**SCIENCE ANNEX 1<sup>ST</sup> AND 2<sup>ND</sup> FLOOR RENOVATION**  
**NAU Project #09.200.201**  
**July 14, 2020**

**ADDENDUM #2**

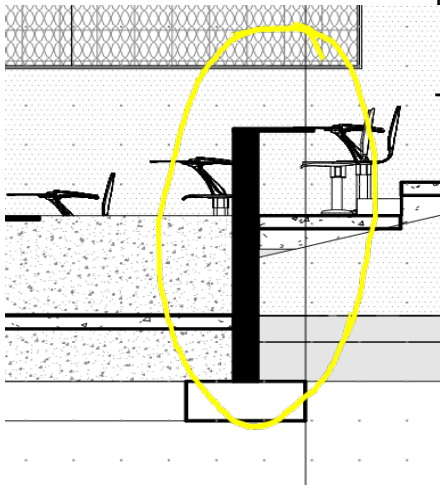
77. **Question:** Would you please clarify if there is a new structural footing and structural concrete wall at the bottom of the lecture hall rooms 106 and 113 where the concrete stairs are removed? It appears as though one is added at each of the two lecture halls as detailed on sheets A1.13 and A4.01, but there is no reference to structural plan sheets or details. Please see below:

**Answer:** These are noted on the revised drawings included with this addendum.
